1CAN090401

SUBJECT: License Amendment Request
Proposed Technical Specification Change for Revision to ANO-1 Steam
Generator Tube Inservice Inspection Program
Arkansas Nuclear One, Unit 1
Docket No. 50-313
License No. DPR-51

Analysis of Proposed Technical Specification Change

FIGURE 5.5.9-1

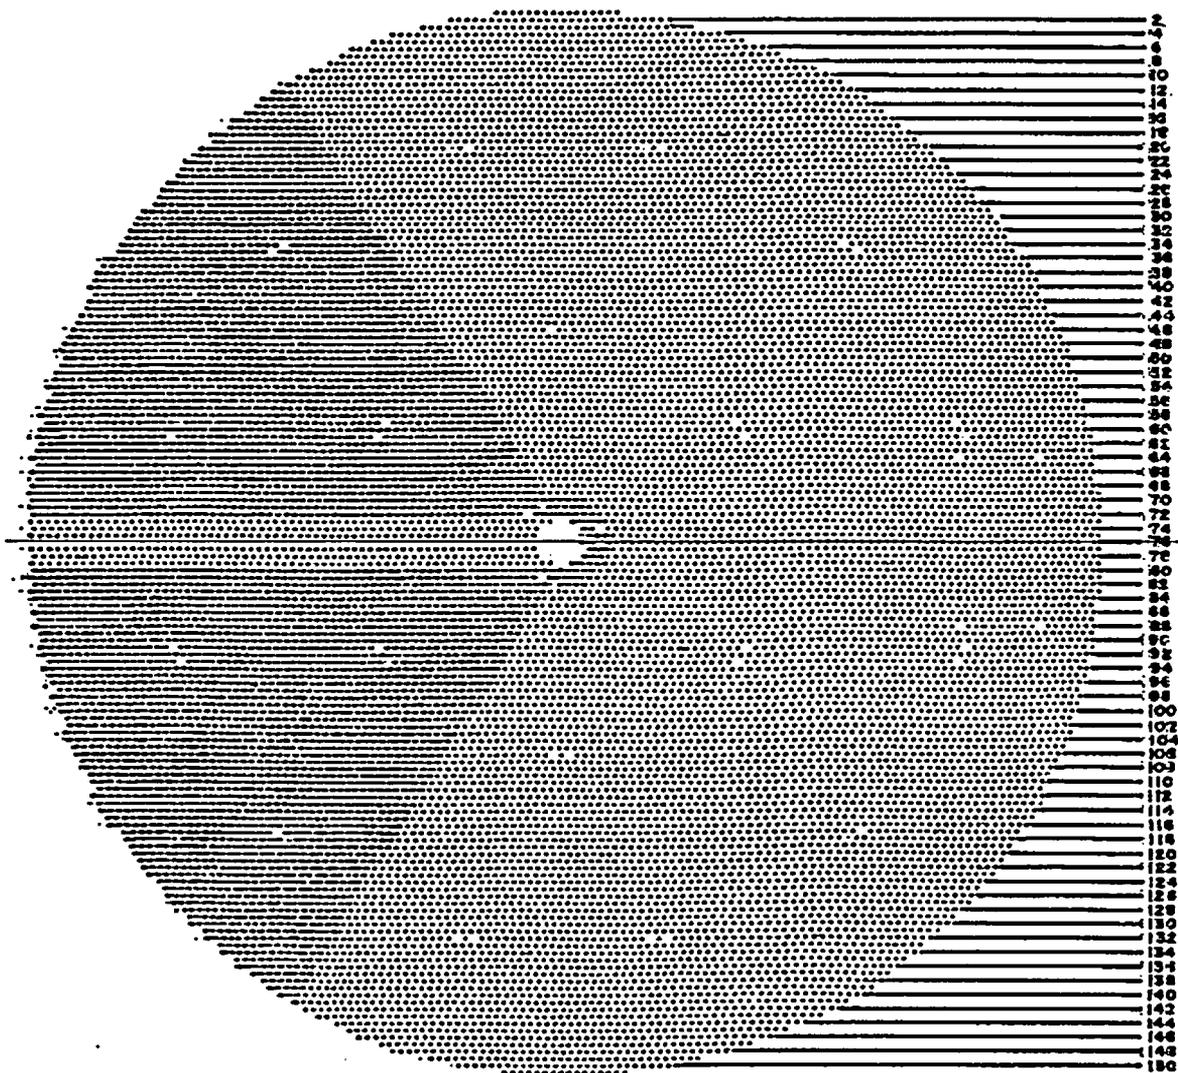
- (1)—~~Group A-1: Tubes within one, two or three rows of the open inspection lane.~~
- (2)—~~Group A-2: Unplugged tubes with sleeves installed.~~
- (3)—~~Group A-3: Tubes in the wedge-shaped group on either side of the lane region (Group A-1) as defined by Figure 5.5.9-1.~~
